Re: McDonald's/Ager Road/DSP-22001

IN RE: DETAILED SITE PLAN DSP-22001 AND
DEPARTURE FROM DESIGN STANDARDS DDS-23001
PROPOSED MCDONALD'S RESTAURANT
GREEN MEADOWS SHOPPING CENTER
6565 AGER ROAD, HYATTSVILLE, MARYLAND 20782

SUBJECT: **DSP-22001: McDonald's Ager Road**
Planning Board Agenda October 24, 2024 – Staff Revisions to Technical Report

Figure 1. Map of subject parcel (dot-dash red line).

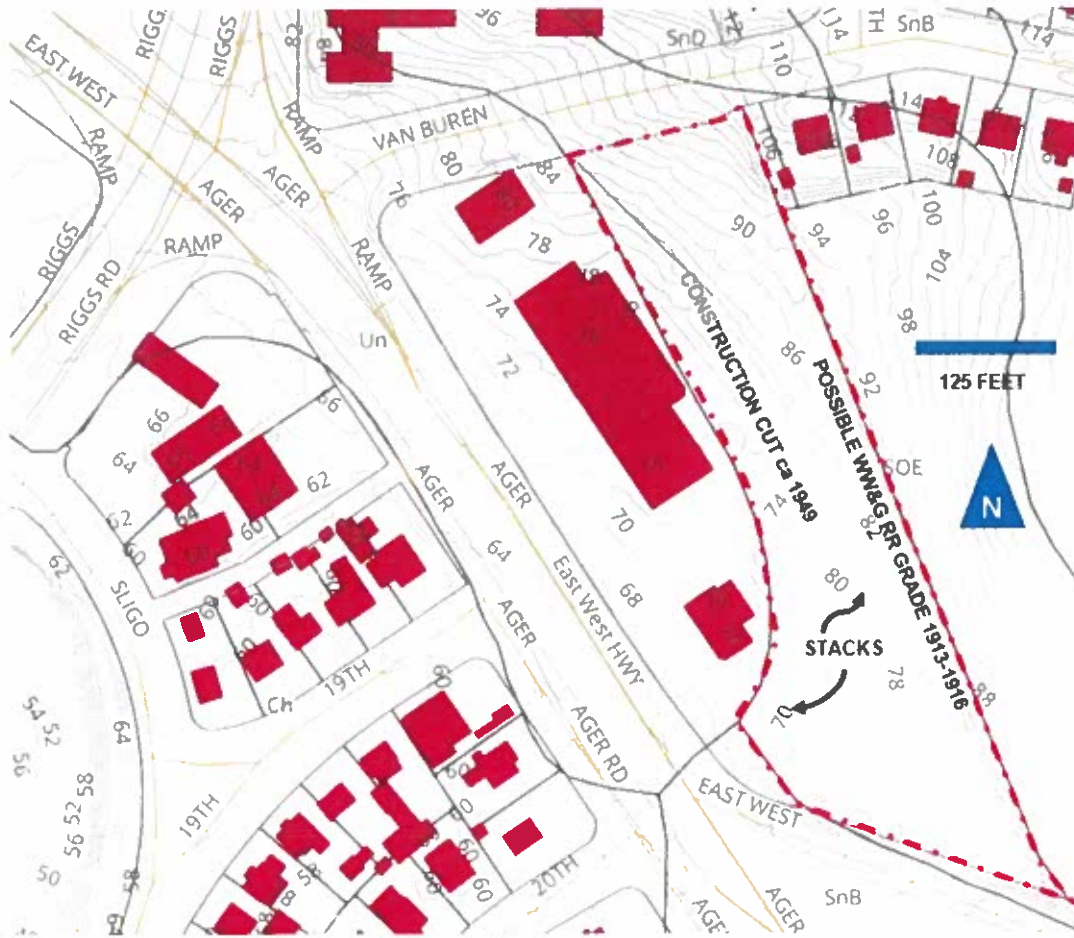
1. The level strip bordering the seminary fence (Figure 1) appears to be a surviving remnant of the *Washington, Westminster & Gettysburg Railroad* (18PR432), portions of which I have identified just north of the Ager Road crossing of the Northeast Branch of Anacostia River and west of the river at 6203 Ager Road (Gibb and Creveling 1993, Gibb 2023). See historical note below. The early 20th-century grade was never completed.

2. Construction on the commercial lot on the west (Map 41, Parcel 23), possibly dating to 1949 or subsequent improvements, cut into the hillside behind those establishments (Figure 4).

3. There are several stacks of stone and concrete rubble (Figure 2) on the parcel. These lie directly on, but are not embedded within, the ground; i.e., they were stacked recently. They are improvisational seats and not grave markers (Figure 3).

Figure 1. Internal Traffic Calming Elements

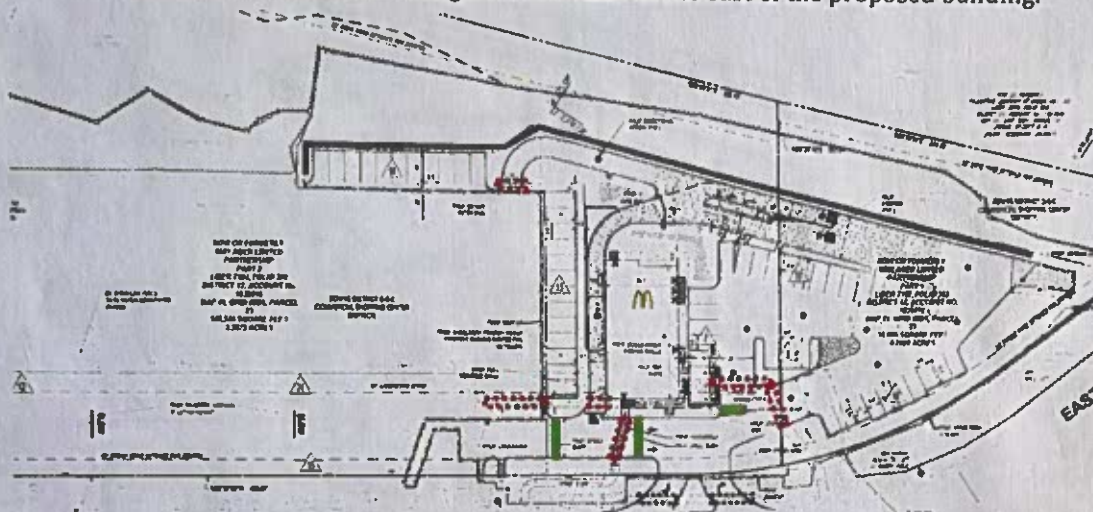
- a. **Improvements to internal circulation:** Exhibit 2 shows an internal circulation design that facilitates accessibility to all buildings within the shopping center, as users may navigate through drive aisles, sidewalks, or crosswalks; thereby, reducing the need for vehicles or pedestrians to utilize the adjacent roadways.

To reduce the speed of entering vehicles and protect pedestrians from the existing on-site traffic, high-visibility traffic calming elements are proposed within the site. As shown in the figure below, additional pavement markings, crosswalks (highlighted in red), and speed bumps (highlighted in green) were added near the driveway entrances and along the drive aisle to the east of the proposed building.

Figure 2. Proposed Crosswalks and Sidewalk

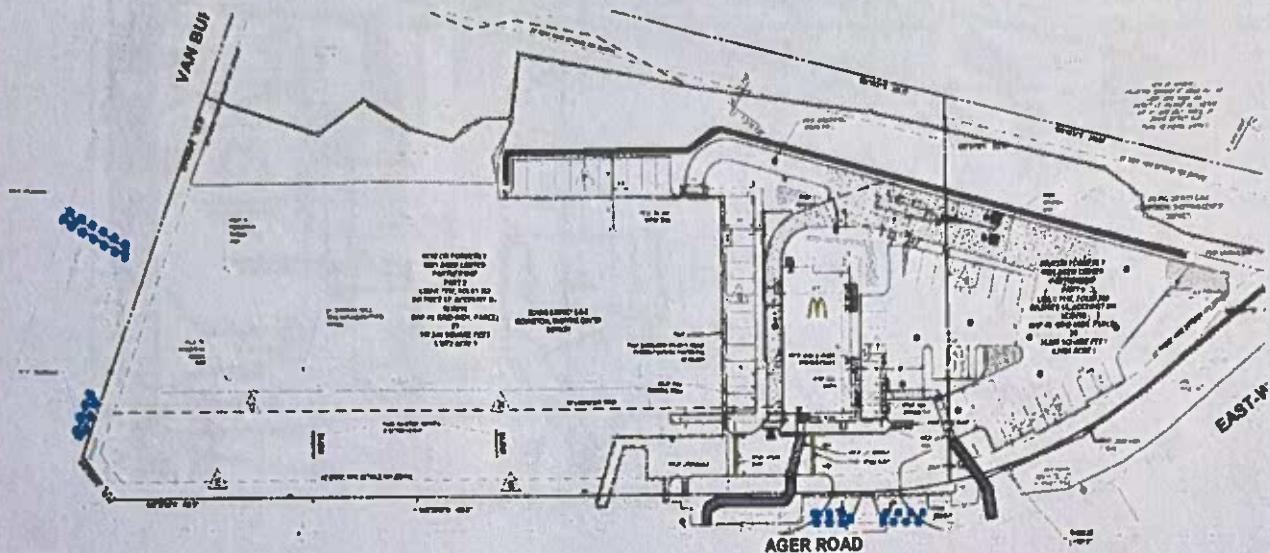
- The northern edge of the property, north of the intersection of Van Buren Street and Ager Road
- East of the existing building
- At the drive-through exit

- Along the western edge of the property
- Near the southernmost driveway, close to the existing crosswalk across MD 410 (East West Highway)

Figure 3. Drive-through Queuing

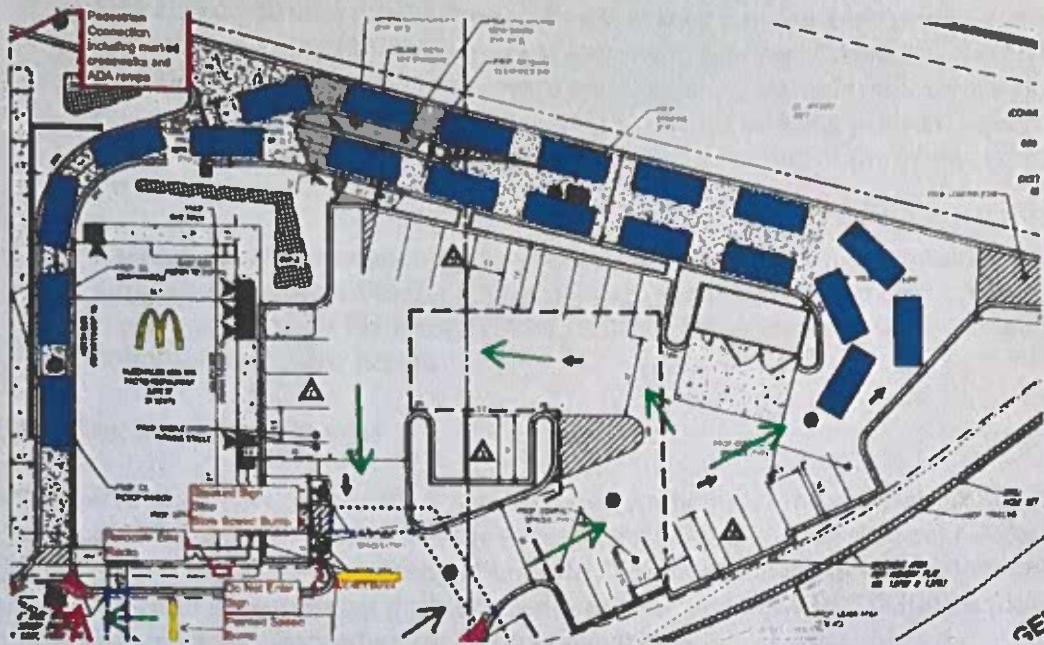
- c. **Drive-through queuing analysis:** Exhibit 3 includes a queuing analysis submitted by the applicant for the drive-through lane portion of the proposed development. As shown below, the plan allows for approximately 12 to 14 vehicles in the double drive-through lanes, from the order lane to the drive-through entrance, and additional space is available to accommodate 6 more vehicles between the pickup window and the order board. More importantly, the illustration shows that, according to Section 27-274(C)(6) of the prior Zoning Ordinance, the design of the drive-through does not conflict with circulation traffic patterns or pedestrian access.
